## DESERT TORTOISE COUNCIL

16 August 2019

RE: Comment Letter on the Proposed Gemini Solar Project, Clark County, Nevada: Resource Management Plan Amendment and Draft Environmental Impact Statement

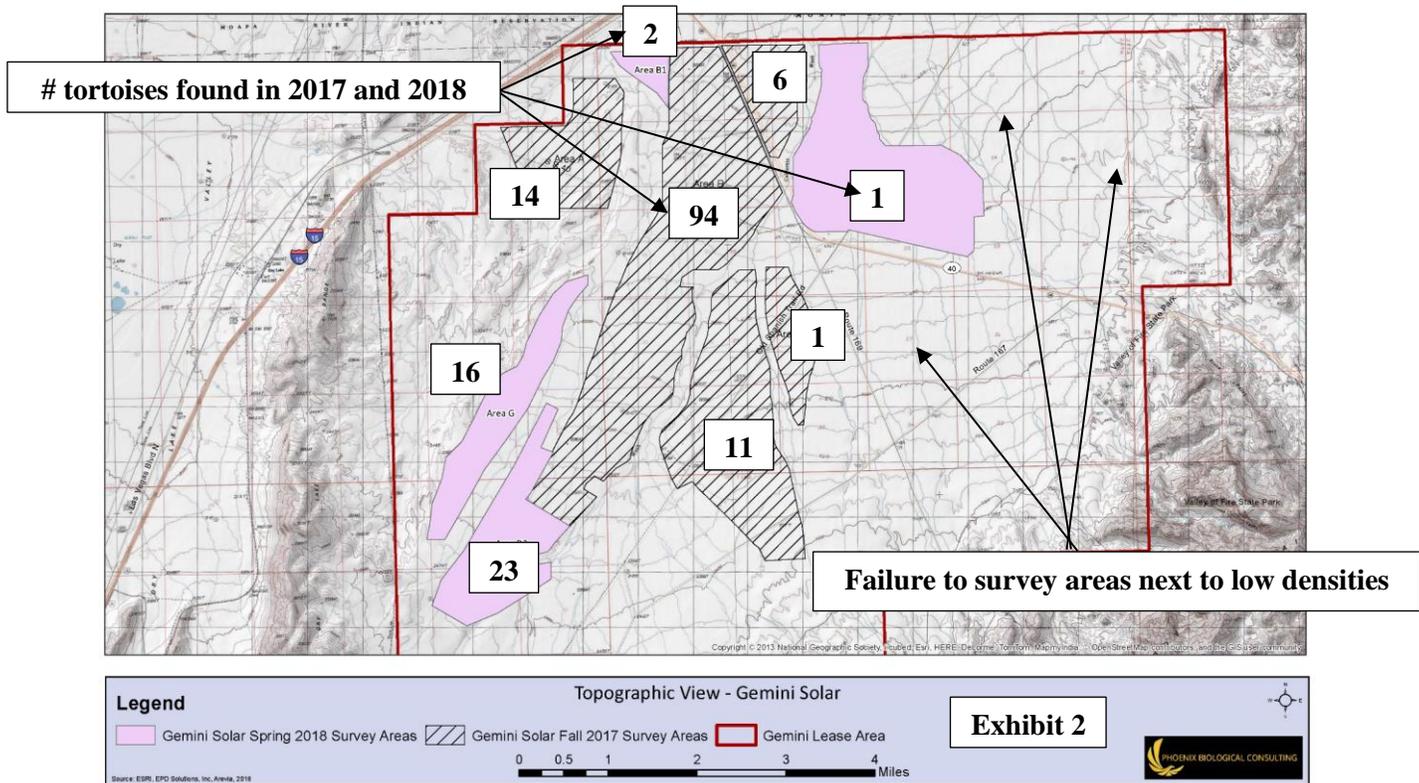
(3) The proponent has failed to select a site where habitats are largely degraded and unsuitable for tortoises. We believe the proponent has failed to consider a range of alternative sites either lacking tortoises or supporting few individuals. The proponent does not justify or demonstrate the need to provide 690 megawatts of alternating current in the first place, then claims that brownfields are too small and private lands too expensive. We believe, rather, that the proponent should have analyzed an alternative that reduces the energy output so that brownfields and/or private lands could have been economically feasible. This is typical case where the site was preselected without the benefit of environmental analysis being a part of the site selection process. Although the studies reveal significant impacts, the proponent is not willing to alter the size and location of the development footprint to minimize impacts.

(4) The proponent has not analyzed a range of alternatives that include variable site locations even within the 44,000-acre ROW application area. Rather, the same acreage (i.e., 7,097 acres) would be impacted by different approaches with varying levels of impacts (i.e., mowing versus grubbing). The proponent identifies a 44,000-acre study area, surveyed 7,481 acres in 2017 (Phoenix Biological Consulting 2018a) and 3,722 acres in 2018 (Phoenix Biological Consulting 2018b), with no apparent overlap, so only 11,200 of the 44,000 acres have been surveyed. The Proponent has subsequently chosen to develop a 7,100-acre± portion of that area with no regard for tortoise densities revealed by their funded studies. Importantly, there are approximately 32,800 acres of lands to the east and south of the 11,200 acres surveyed in 2017 and 2018 that may support significantly fewer tortoises than the chosen impact area. We find it telling that none of the 3,722 acres surveyed in 2018 were selected for project development, even though one of those areas, the 1,832-acre Area F, had only one tortoise. It's as if the 2018 surveys were a formality as only the 2017 survey areas have been identified for project development.
